February 27, 2014
Serial: MNS-14-023

Subject: Second Six-Month Status Report in Response to March 12, 2012, Commission Order
Modifying Licenses with Regard to Reliable Spent Fuel Pool Instrumentation (Order
Number EA-12-051)

**McGuire Nuclear Station Response to Spent Fuel Pool Instrumentation
Interim Staff Evaluation Request for Additional Information Regarding
Overall Integrated Plan for Implementation of Order EA-12-051.**

UNIT 1
FIGURE 2
PRIMARY & BACK-UP LEVEL CHANNEL CABLE ROUTE PLAN
SPENT FUEL POOL

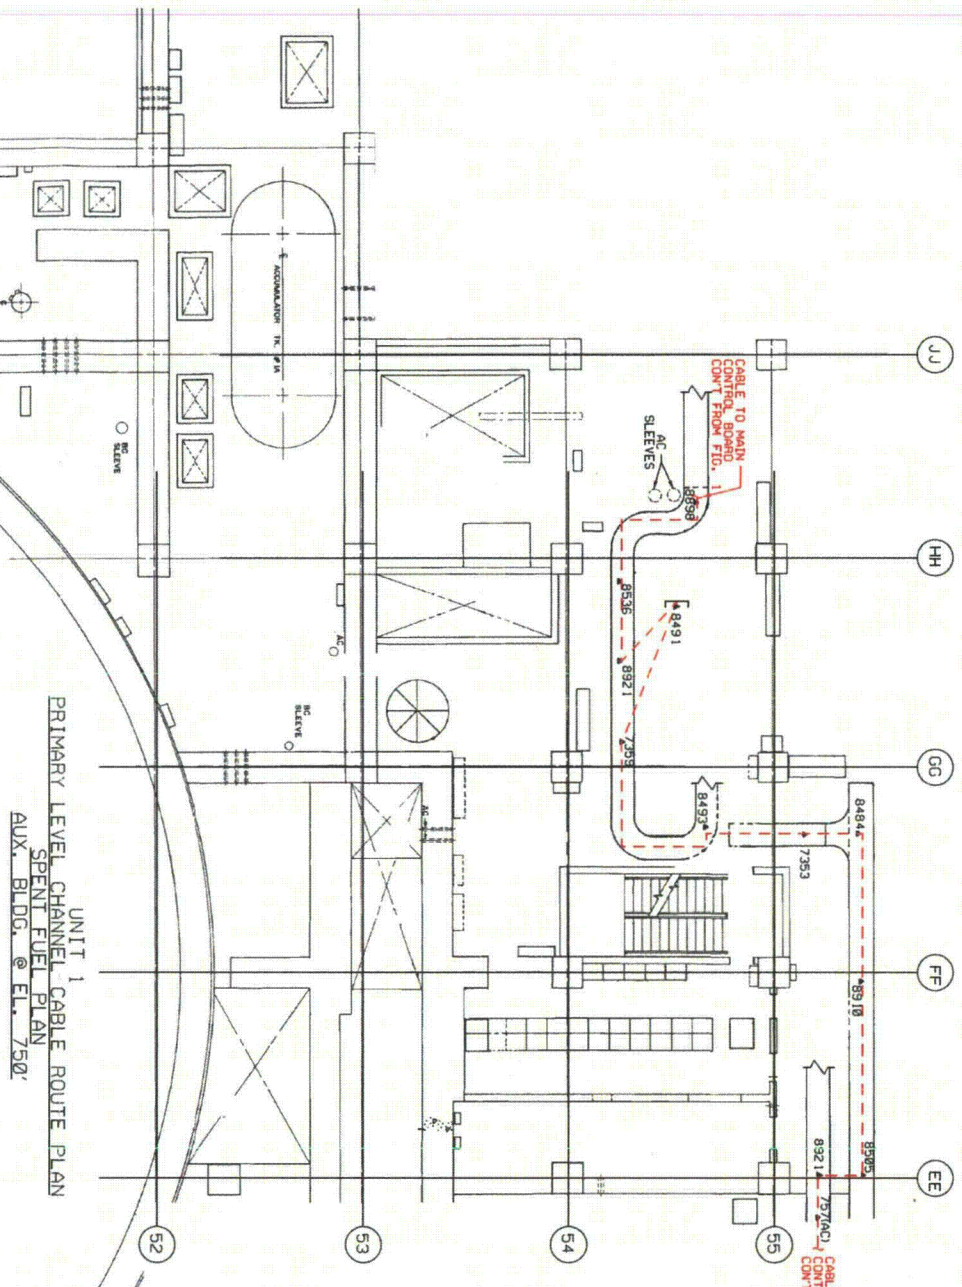
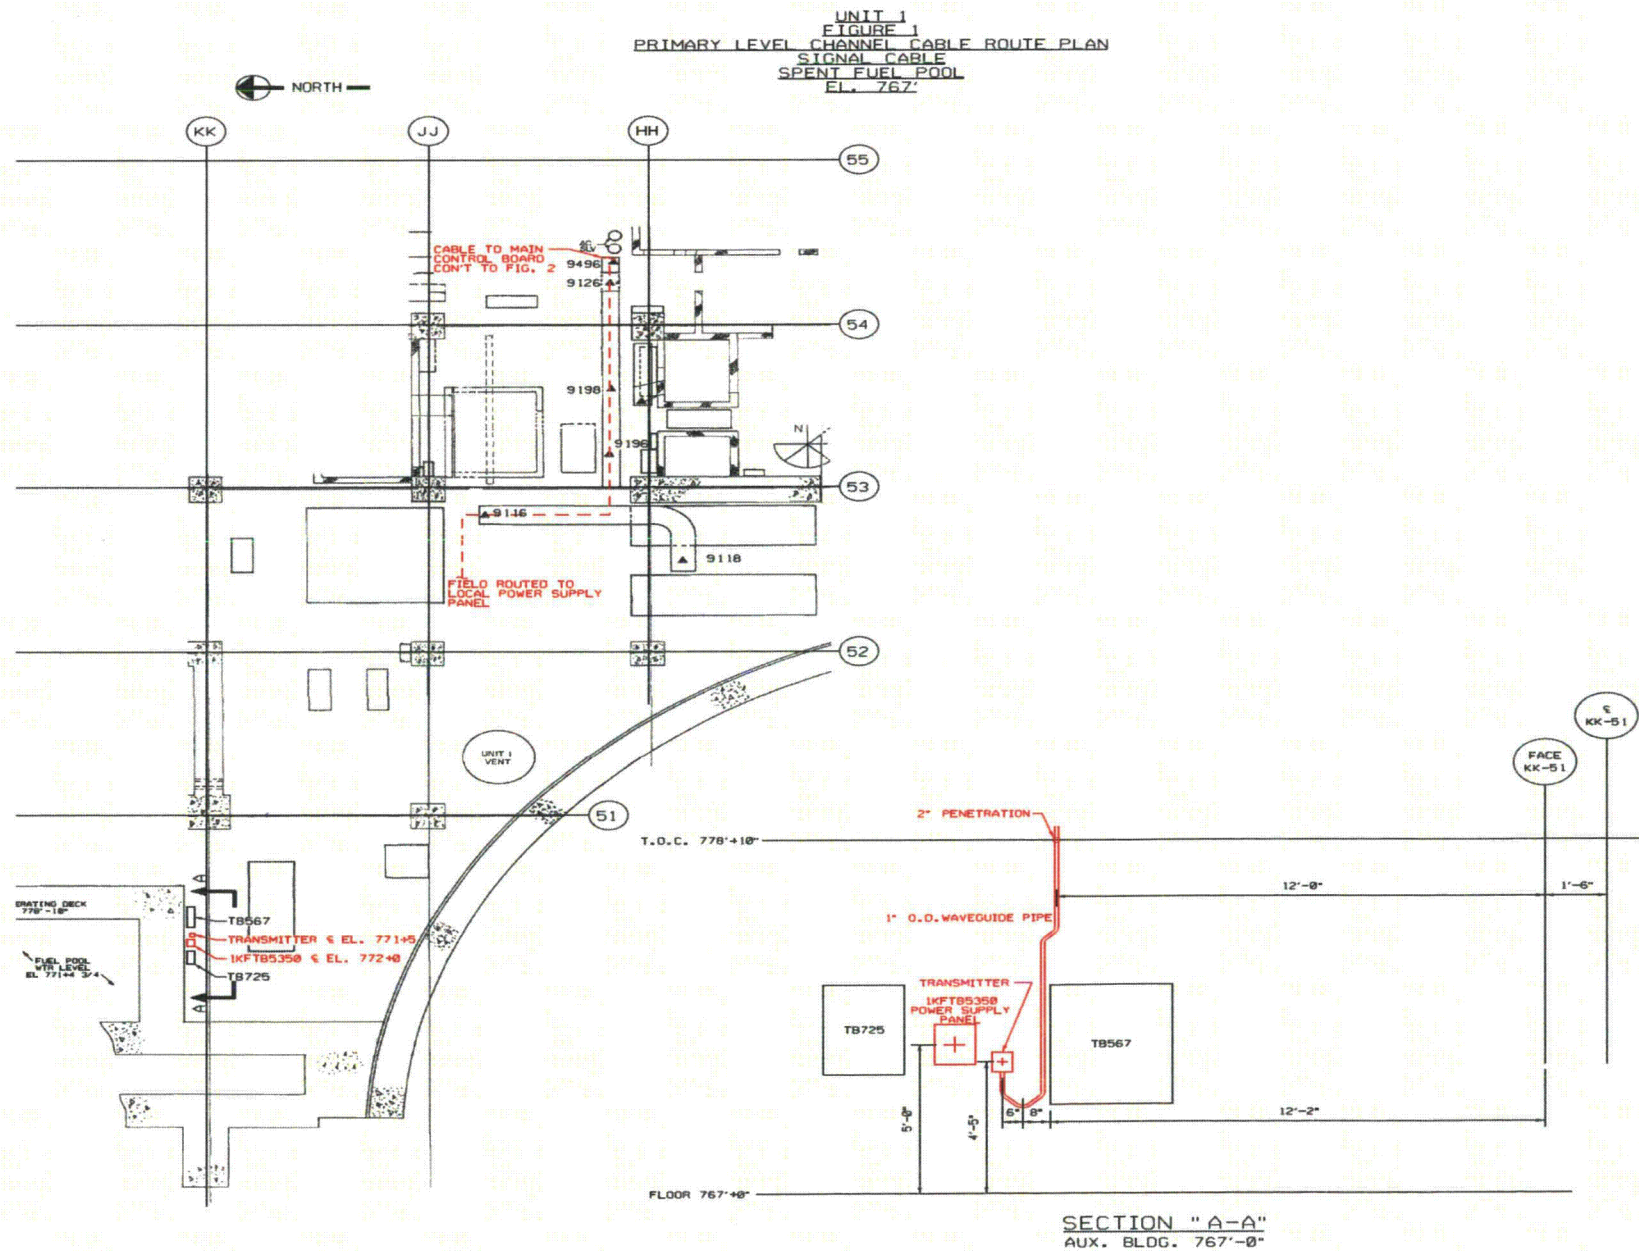
Please provide additional information describing how the proposed final arrangement of the primary SFP level instrumentation and routing of the cabling between the level instruments, the electronics and the displays, meets the Order requirement to arrange the SFP level instrument channels in a manner that provides reasonable protection of the level indication function against missiles that may result from damage to the structure over the SFP.

Please provide the NRC staff with the final configuration of the power supply source for each channel so that the staff may conclude that the two channels are independent from a power supply assignment perspective.

The planned routing for the primary level channel cabling is depicted in Figures 1-4 and Figures 5-8 for Units 1 and 2, respectively. Figures 2 and 7 depict the relative proximity of the back-up channel components to the primary channel components.

FIGURE 9
SCHEMATIC LAYOUT DRAWING FOR
MNS UNIT 1
VEGA WAVEGUIDE PIPE, TRANSMITTER,
VEGAPULS 62ER SENSOR, AND
MOUNTING SUPPORTS

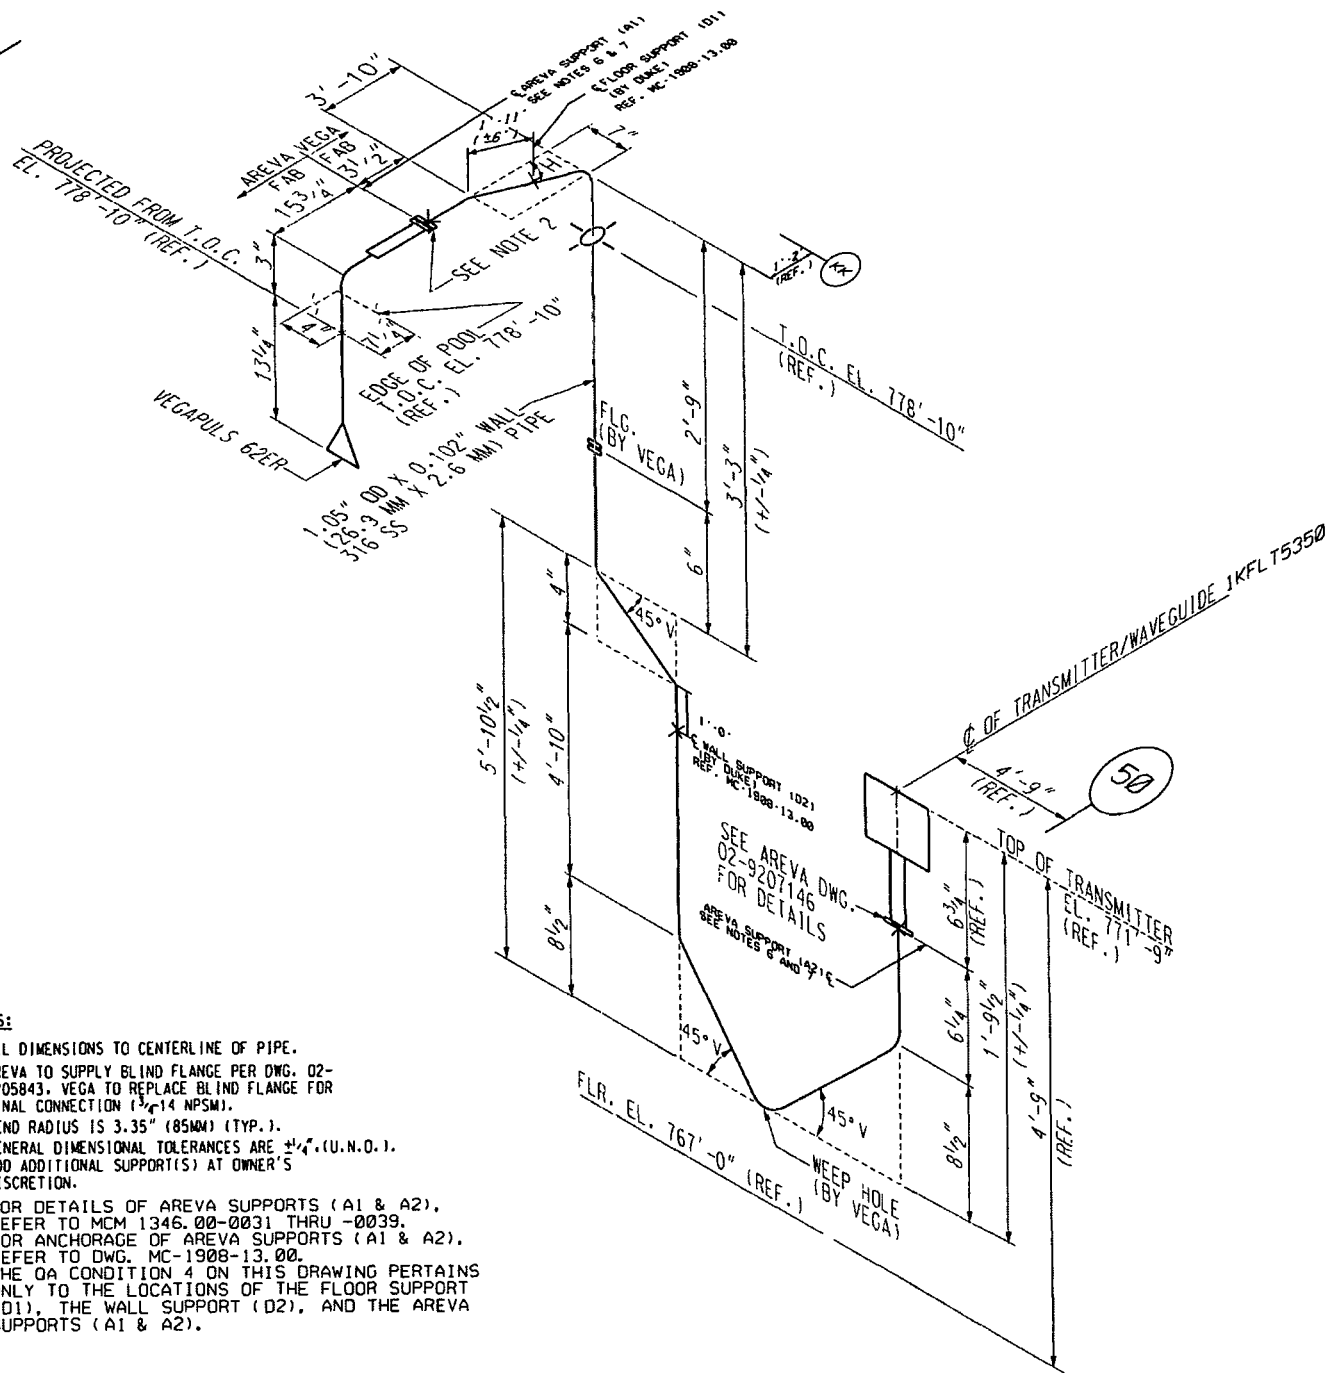
- b) A description of the manner in which the level sensor (and stilling well, if appropriate) will be attached to the refueling floor and/or other support structures for each planned point of attachment of the probe assembly. Indicate in a schematic the portions of the level sensor that will serve as points of attachment for mechanical/mounting or electrical connections.**

The wave guide piping assembly, horn, and electronic sensor are designed to attach to the SFP concrete floor and the Auxiliary Building concrete wall by means of mounting supports. These mounting supports consists of a sensor support, horn support, and intermediate supports. Spacing of the mounting supports comply with site specific specifications and standards and qualification restrictions for the wave guide pipe assembly. Figures 9 and 10 depict the planned attachment points for the wave guided piping and horn assembly for Units 1 and 2, respectively.
